Memorandum

Date: (09/13/2012)
To: Sara Imhulse – Riverdale Park City Manager
From: Paul Mortensen
Re: Response to the Preliminary Plan of Subdivision 4-12004
Drawings Signed and Dated on 7-24-12

• **Diagram A1**

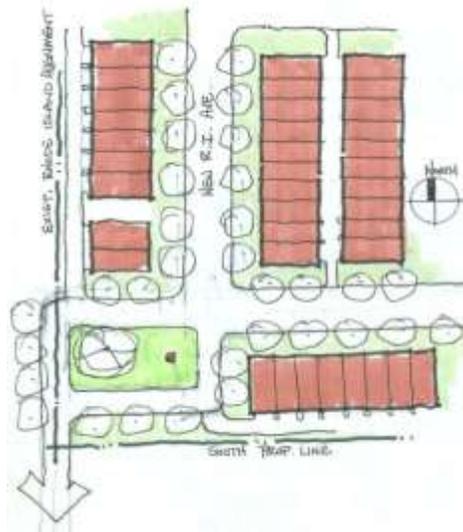
- At the northern end of the site, the existing Rhode Island Avenue trail right-of-way north to College Park intersects into the public Woodbury Street on site. This direct connection of the public realm allows for a clear understanding of what is public street and trail versus what is private residential land. It also allows for future public improvements on the right-of-way land to build better connections between Riverdale Park, the Cafritz property and College Park. However, the southern trail connection back to the exiting Rhode Island right-of-way that connects to the Riverdale Park Town Center Plaza is not direct. It appears that a small piece of land is given to the trail to make the connection but it is confusing between what is public realm and what is the private realm of the townhouses at this attempted trail connection. We believe this connection from the existing Rhode Island right-of-way to the new Rhode Island Avenue trail must be direct and overtly public in order to relieve confusion and to allow for future improvements and connections between the new street and the existing Hiker/Biker trail to the south. One solution to this connection might be the following:

- The proposed arrangement of townhouses at the southwest corner of the site limits the possibility of creating a vehicular connection along Rhode Island Avenue to the existing Town Center Plaza. By removing some, or all of the last bar of townhouses at the western side of the new Rhode Island Avenue, a traffic circle, or some alternative terminus could be created here that allows for a direct future connection to the existing alignment. See [Diagram A1](#) for clarification of this alternative.
